<b>ITEM: 6.14</b>	<b>COMMITTEE OF ADJUSTMENT REPORT SUMMARY MINOR VARIANCE APPLICATION FILE NUMBER A261/22 46 INTERSITE PLACE, WOODBRIDGE</b>
-------------------	---

**COMMITTEE OF ADJUSTMENT REPORT  
MINOR VARIANCE APPLICATION  
A261/22  
46 INTERSITE PLACE, WOODBRIDGE**

<b>ITEM NUMBER: 6.14</b>	<b>CITY WARD #: 2</b>
<b>APPLICANT:</b>	Maria Marotta and Rosemary Marotta
<b>AGENT:</b>	Peggy Chiu Architect Inc
<b>PROPERTY:</b>	46 Intersite Place, Woodbridge
<b>ZONING DESIGNATION:</b>	See Below
<b>VAUGHAN OFFICIAL PLAN (2010) DESIGNATION:</b>	Vaughan Official Plan 2010 ('VOP 2010'): "Low-Rise Residential" and "Natural Areas"
<b>RELATED DEVELOPMENT APPLICATIONS:</b>	None
<b>PURPOSE OF APPLICATION:</b>	Relief from the Zoning By-law is being requested to permit a proposed single family dwelling, cabana, swimming pool and increased driveway width.

SHEET TITLE: PROPOSED SITE PLAN

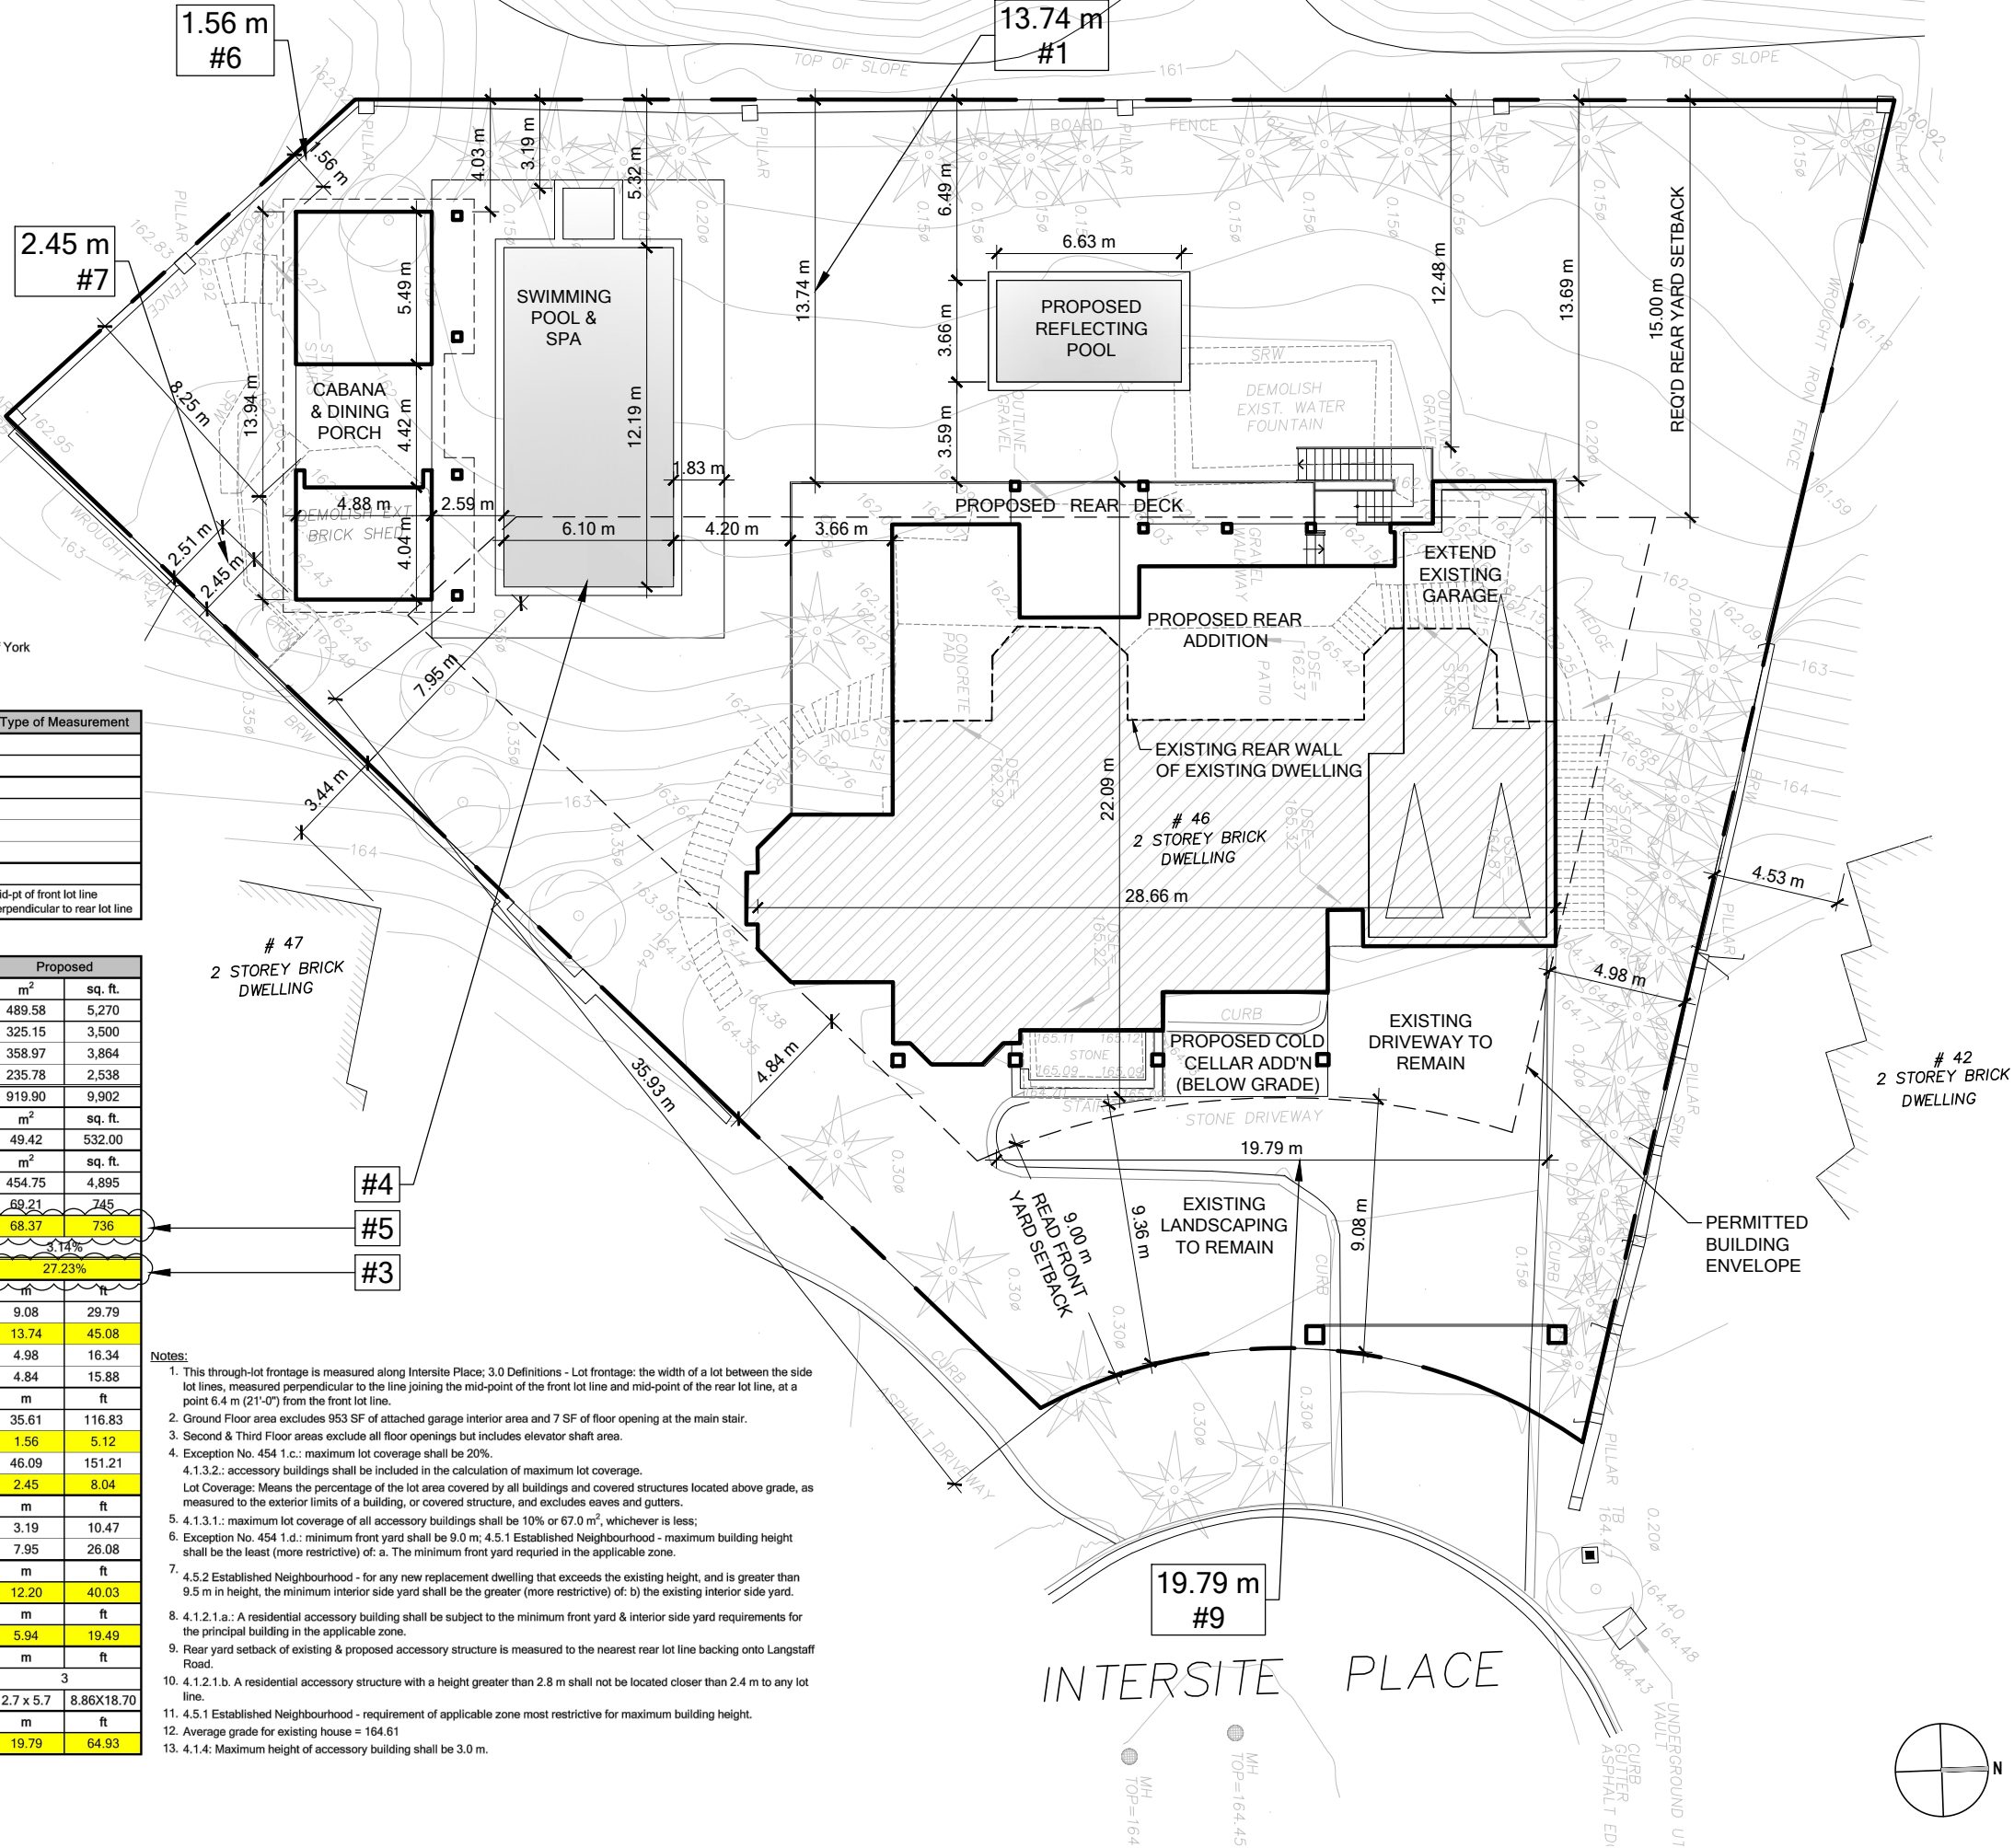
#	Zoning By-law 01-2021	Variance requested
1	A minimum Rear yard of 15 metres is required [Table 7-3].	To permit a minimum rear yard of 13.74 metres.
2	A maximum Height of 9.5 metres is required [Section 4.5.1.a.].	To permit a maximum height of 12.20 metres for the dwelling.
3	A maximum lot coverage of 20% is required [14.454.2.1c.].	To permit a maximum lot coverage of 27.23 %
4	An outdoor swimming pool shall only be permitted in the rear yard of a lot [Section 4.21.2].	To permit an outdoor swimming pool not entirely in the rear yard.
5	In any Residential zone, the maximum lot coverage of all accessory buildings and residential accessory structures shall be 10% or 67m2, whichever is less [Section 4.1.3.1].	To permit a maximum lot coverage of 68.37 m2 for accessory buildings and residential accessory structures.
6	A residential accessory structure with a height greater than 2.8 metres shall not be located closer than 2.4 m to any lot line [Section 4.1.2.1.b].	To permit a residential accessory structure with a height greater than 2.8 metres to be located 1.56 metres to the rear lot line.

7	A minimum interior side yard of 4.5 metres is required for a residential accessory structure [Section 4.1.2.1. a].	To permit a minimum interior side yard of 2.45 metres for a residential accessory structure.
8	In any Residential zone, the maximum height of a residential accessory structure shall be 3.0 m [Section 4.1.4.1].	To permit a maximum height of 5.94 metres for a residential accessory structure.
9	A maximum driveway width of 9.0 metres is required [Table 6-11].	To permit a maximum driveway width of 19.79 metres.

#	Zoning By-law 01-2021	Variance requested
1	A minimum Rear yard of 15 metres is required [Table 7-3].	To permit a minimum rear yard of 13.74 metres.
2	A maximum Height of 9.5 metres is required [Section 4.5.1.a.].	To permit a maximum height of 12.20 metres for the dwelling.
3	A maximum lot coverage of 20% is required [14.454.2.1c.].	To permit a maximum lot coverage of 27.23 %
4	An outdoor swimming pool shall only be permitted in the rear yard of a lot [Section 4.21.2].	To permit an outdoor swimming pool not entirely in the rear yard.
5	In any Residential zone, the maximum lot coverage of all accessory buildings and residential accessory structures shall be 10% or 67m2, whichever is less [Section 4.1.3.1].	To permit a maximum lot coverage of 68.37 m2 for accessory buildings and residential accessory structures.
6	A residential accessory structure with a height greater than 2.8 metres shall not be located closer than 2.4 m to any lot line [Section 4.1.2.1.b].	To permit a residential accessory structure with a height greater than 2.8 metres to be located 1.56 metres to the rear lot line.

7	A minimum interior side yard of 4.5 metres is required for a residential accessory structure [Section 4.1.2.1. a].	To permit a minimum interior side yard of 2.45 metres for a residential accessory structure.
8	In any Residential zone, the maximum height of a residential accessory structure shall be 3.0 m [Section 4.1.4.1].	To permit a maximum height of 5.94 metres for a residential accessory structure.
9	A maximum driveway width of 9.0 metres is required [Table 6-11].	To permit a maximum driveway width of 19.79 metres.

By-law 001-2021	
1	The applicant shall be advised that the variances for By-law 1-88 are no longer required.

General Comments	
1	The applicant shall be advised that additional variances may be required upon review of detailed drawing for building permit/site plan approval.
2	The subject lands may be subject to Ontario Regulation 166/06 (TRCA - Toronto and Region Conservation Authority).
